Project Name: Ginko Storage

Description: Final site plan approval

RE: **Ginko Self Storage -Final Site Plan/Final Engineering Plan Review-4th Review**
~~Stormwater Maintenance Agreement Review-1st Review~~

Revised Final Site Plan Review for Special Land Use for White Lake Charter Township, Michigan

C-7.0

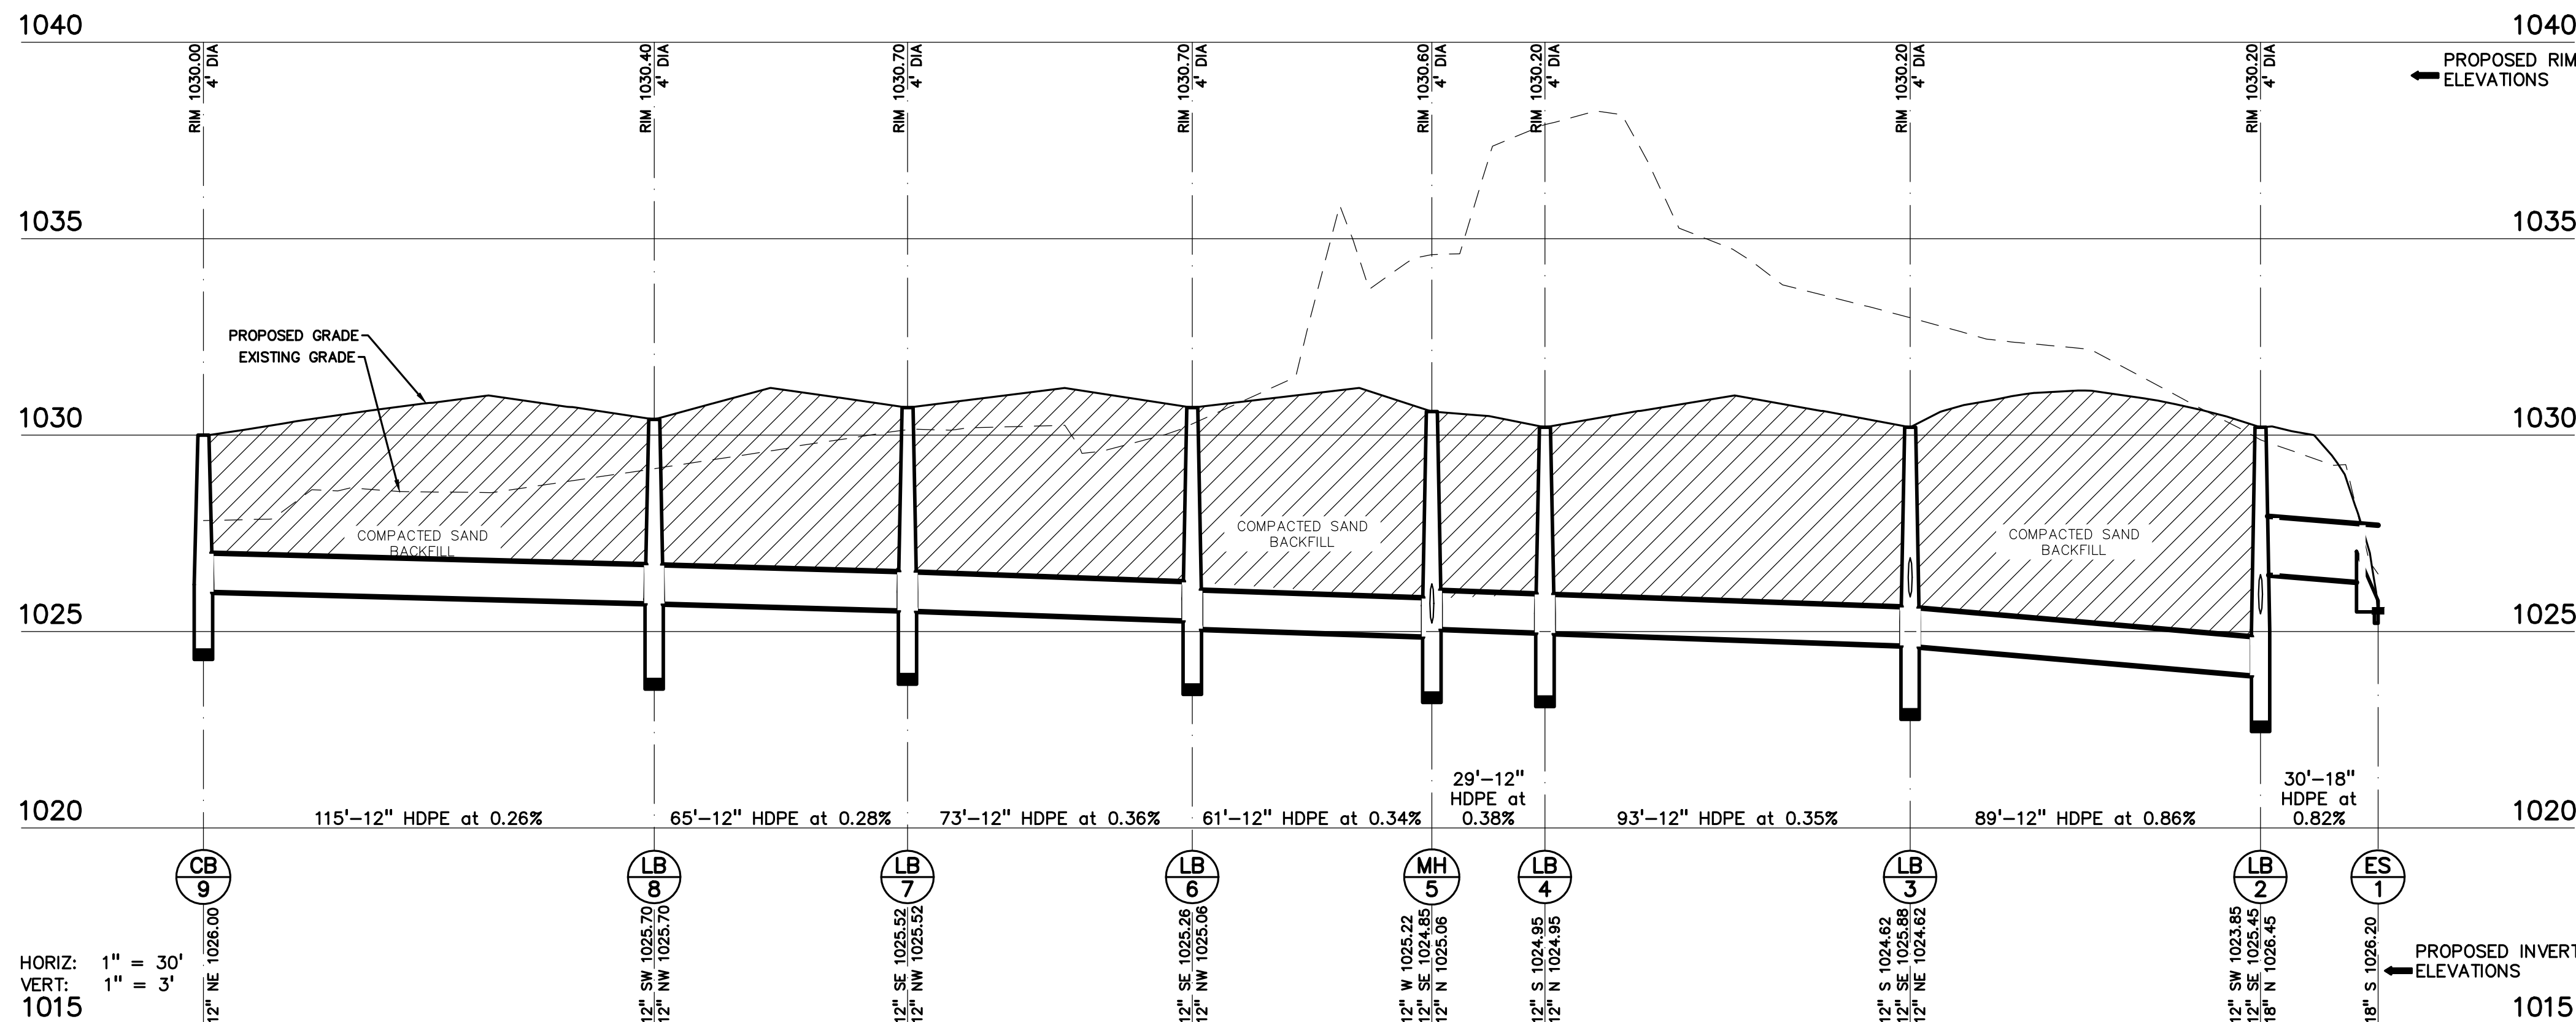
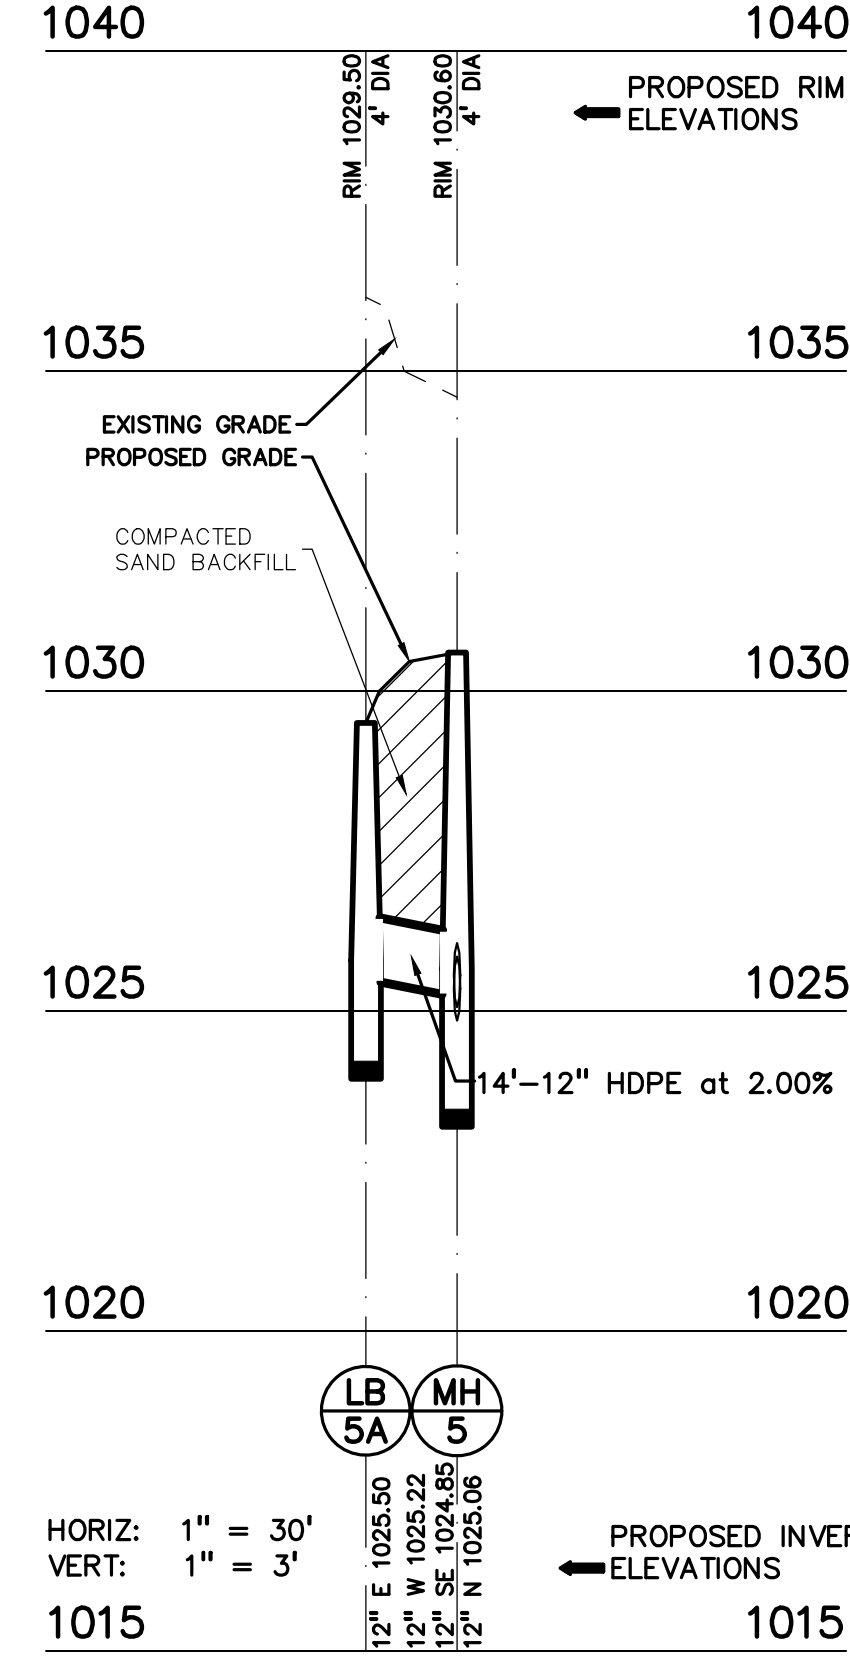
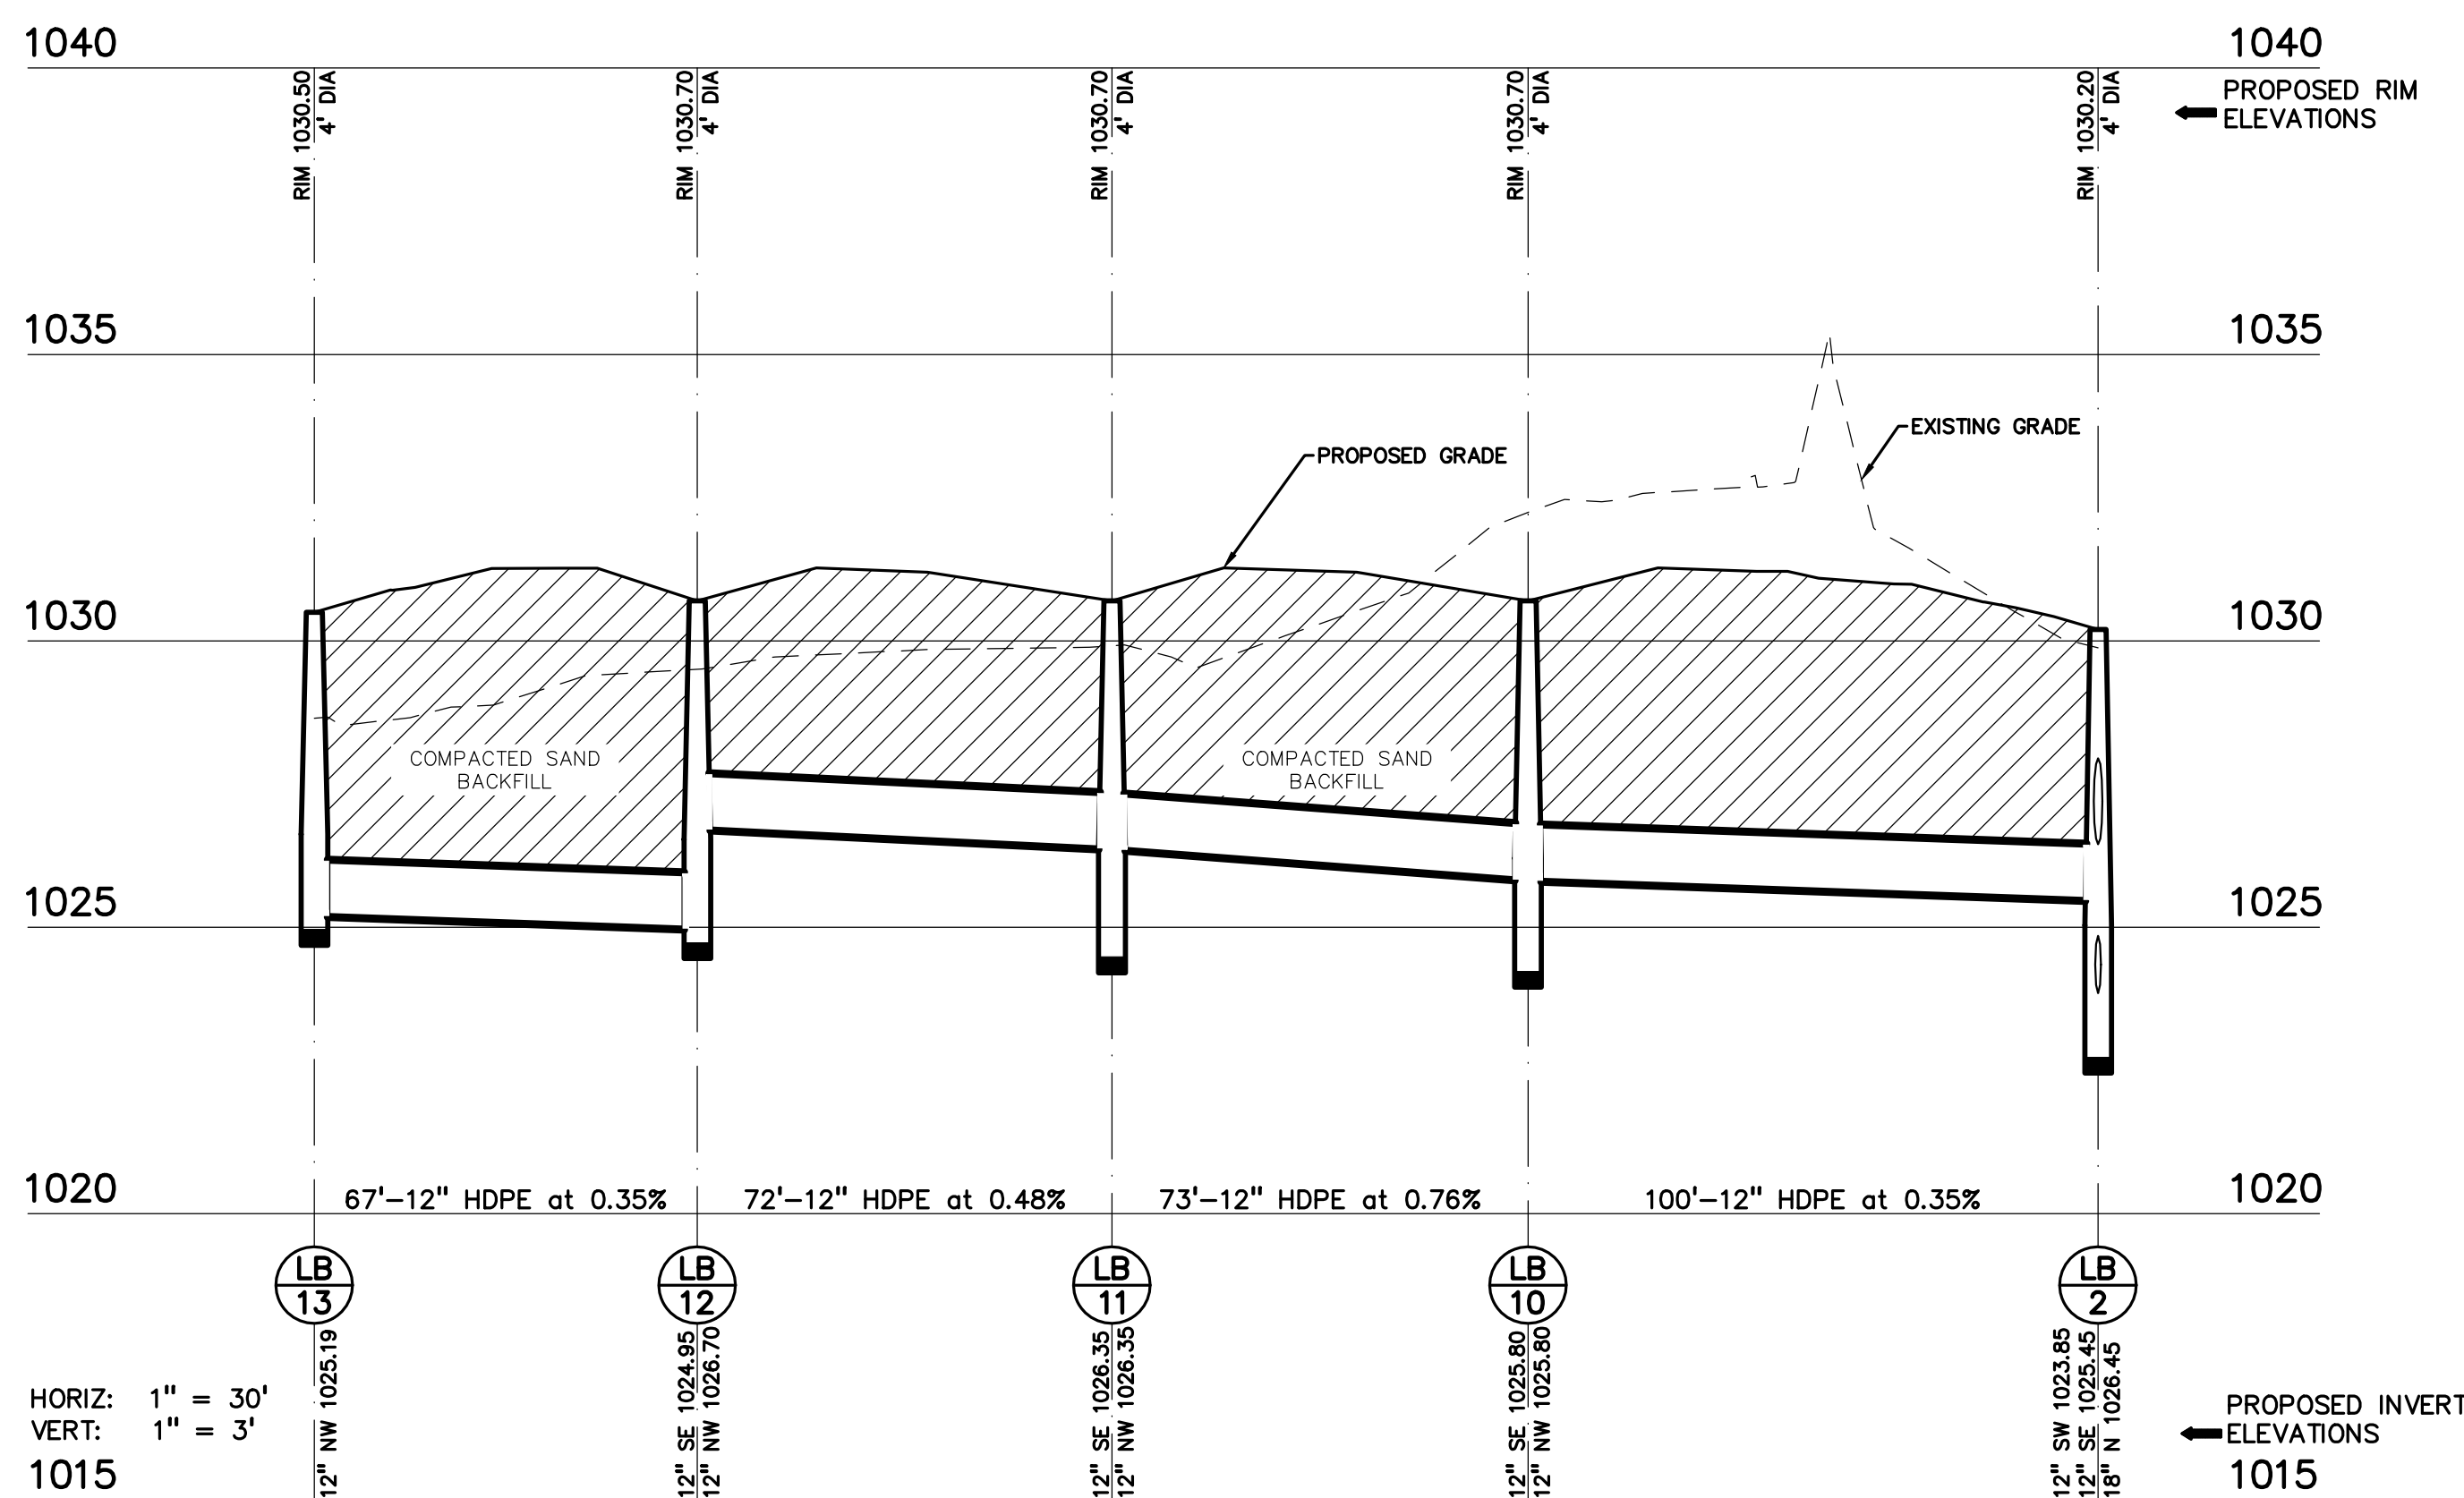
3. Sheet C-7.0- It appears that profiles were not updated based on revised storm sewer structure rim and invert elevations. We have attached a red lined copy of this sheet.
